SERVICE BULLETIN

Subject: Transfer Seat Base
Applicable Products: R12XX Series Products
Affectivity: All units with date codes between January 2006 and May 14, 2007

FIG. 1

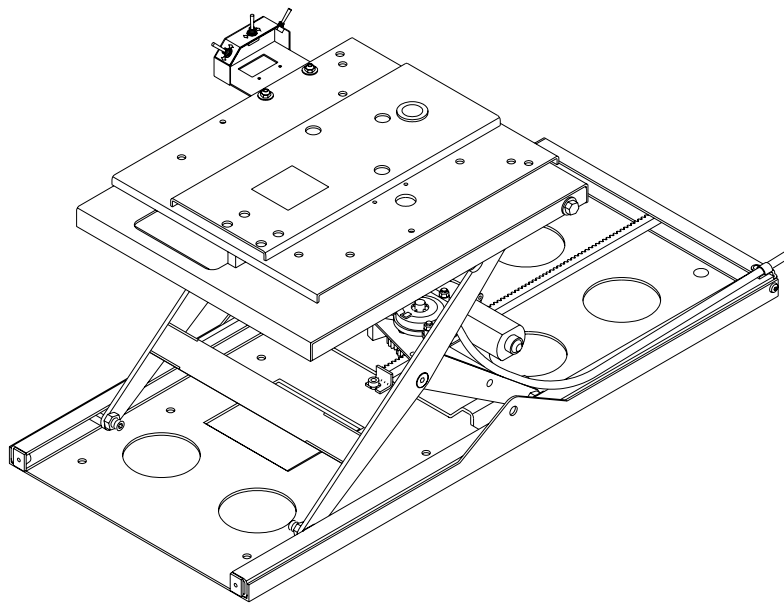
Units have been found wherein the weld that retains the main pivot shaft of the 6-Way Power transfer seat base (Figure 1) has failed, allowing the pivot shaft to fall out of the seat base. Figure 2 illustrates the swivel plate assembly and the defective weld location. Defective welds of this nature may have occurred on up to 770 units made during the above mentioned date range.

Inspect units for proper weld penetration.
